URBAN DESIGN COMMITTEE

TO: **URBAN DESIGN COMMITTEE**

RE: Meeting of October 1, 2019

ITEM 2: Redevelopment at Cotner & P Street

landscape plan

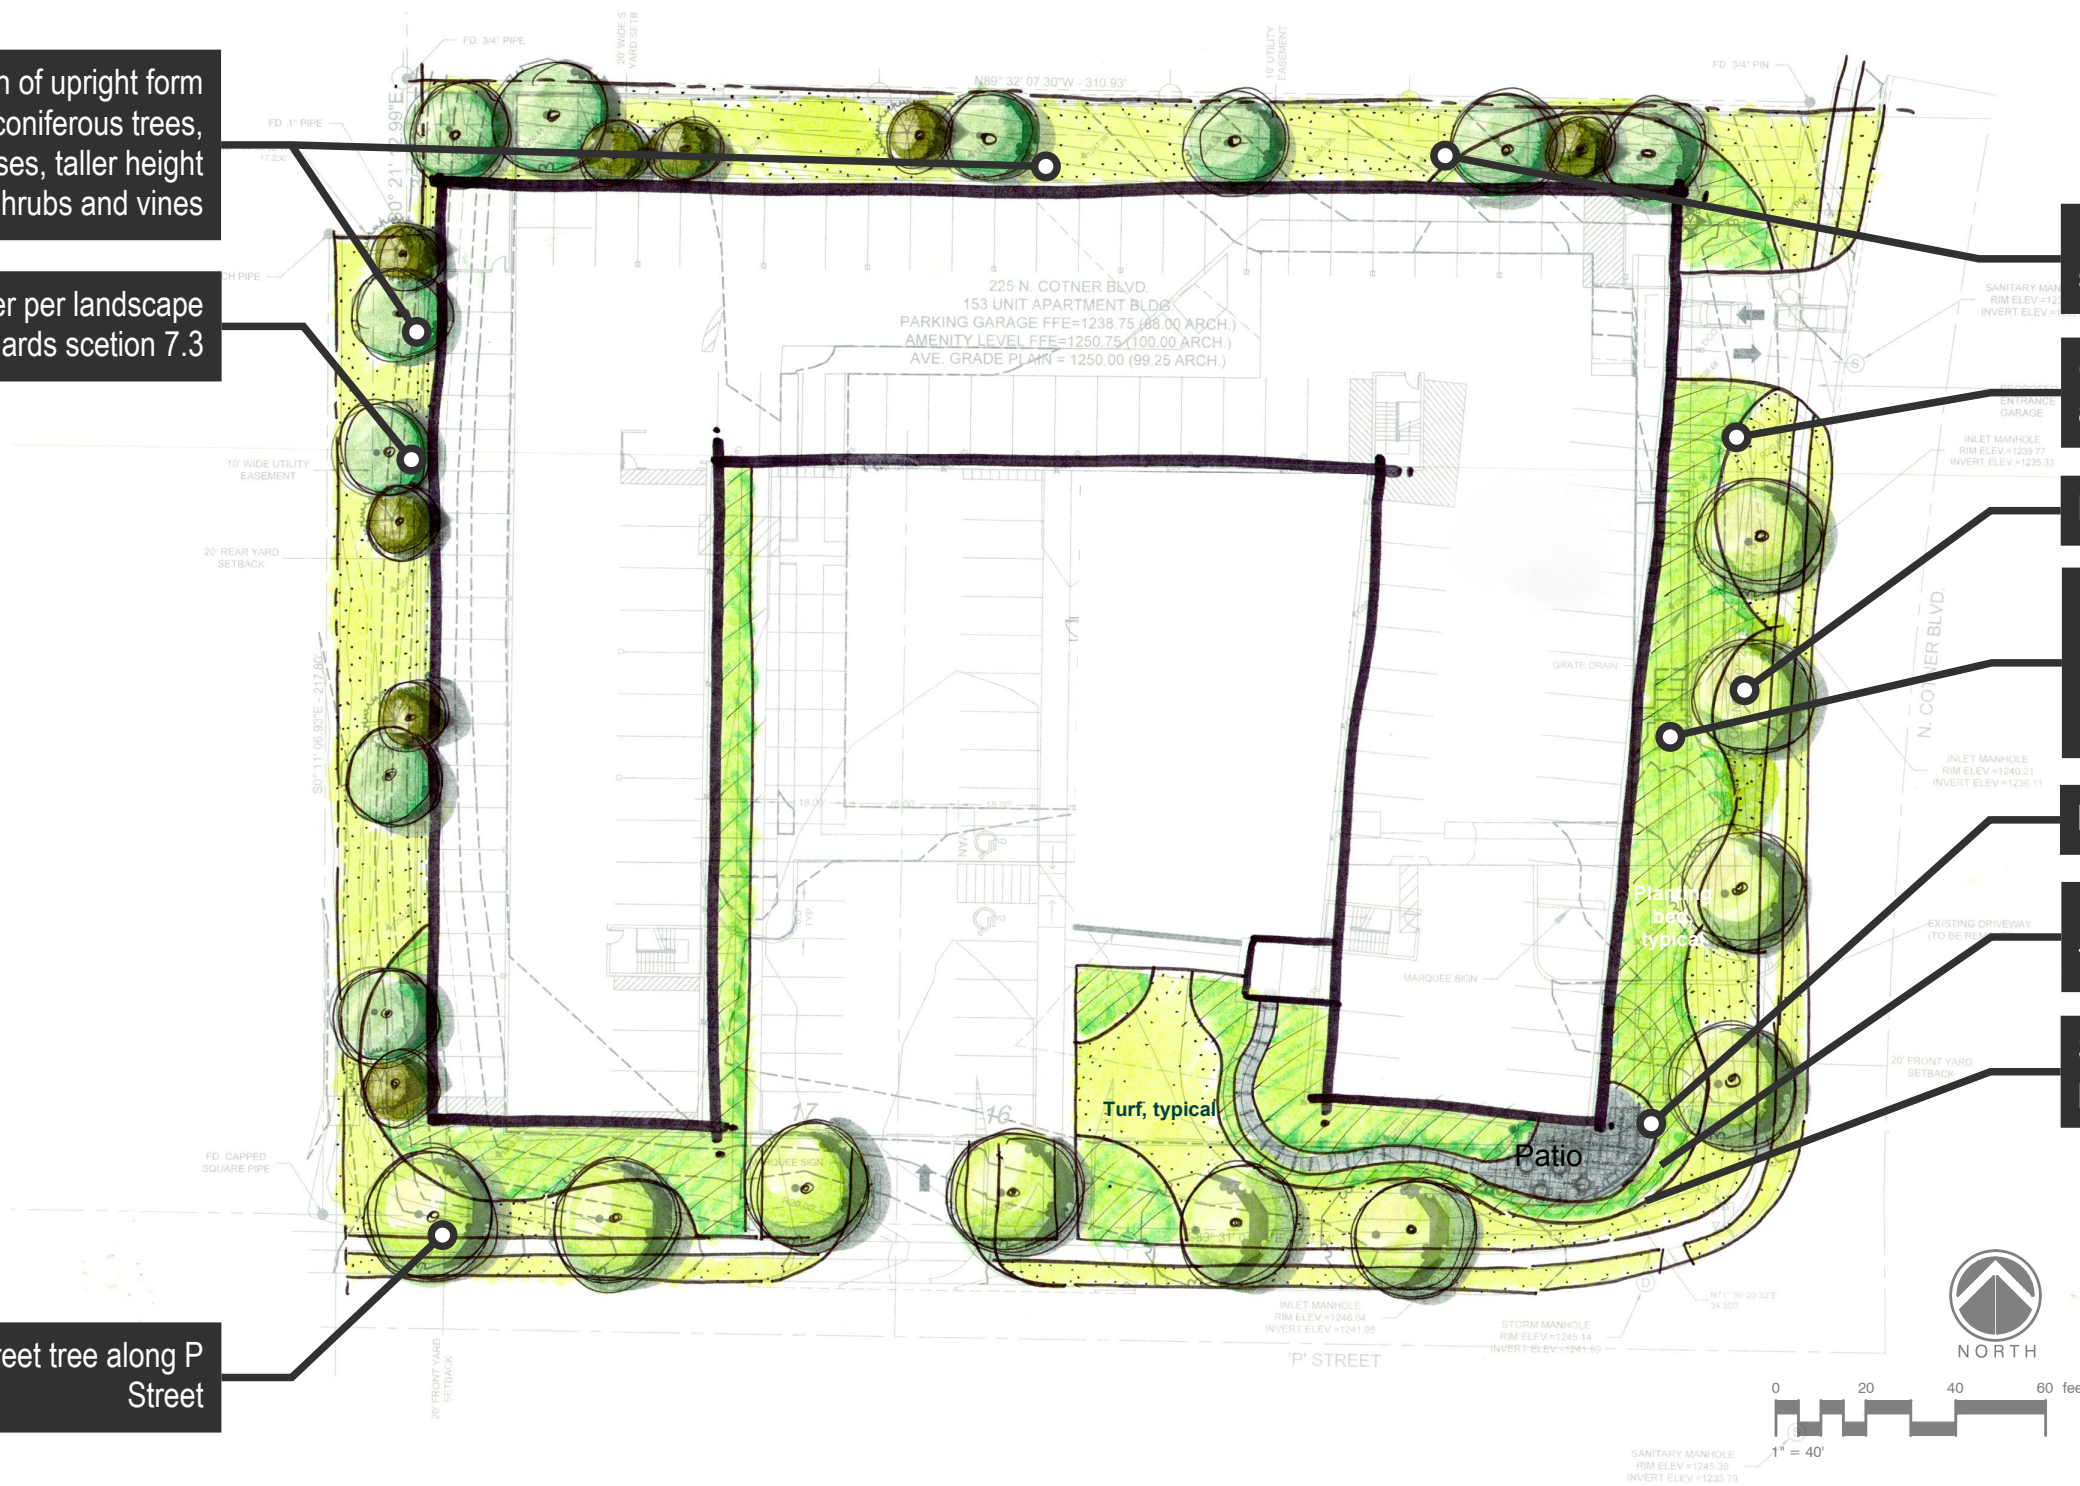
This redevelopment project, proposing to redevelop property at 225 North Cotner Boulevard into a residential building with 153 units, is returning to you for review of their landscape plan. The proposed landscape plan is attached.

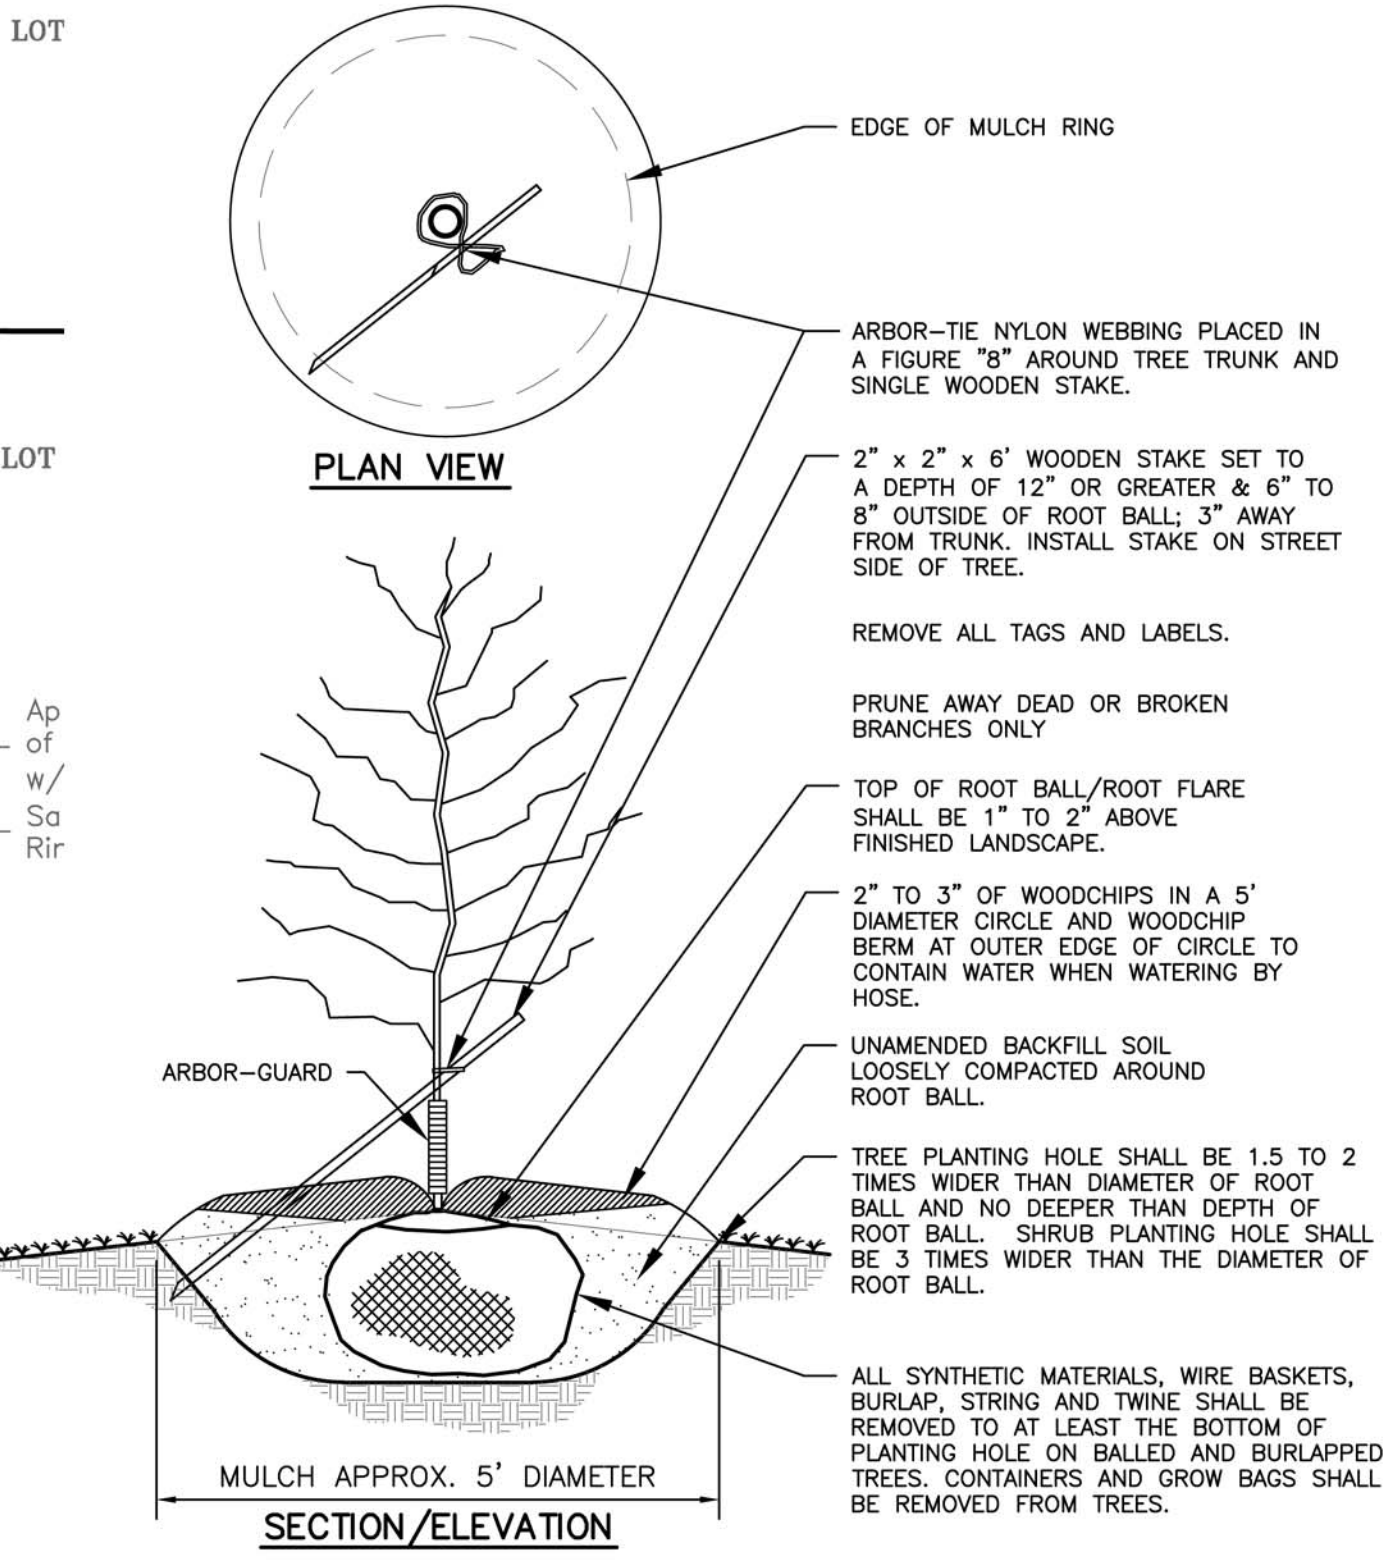
A landscape plan is included for your review. Although it meets the screening and landscaping design standards, I would suggest the Committee recommend that the landscaping be carried around the existing portion of the parking lot.
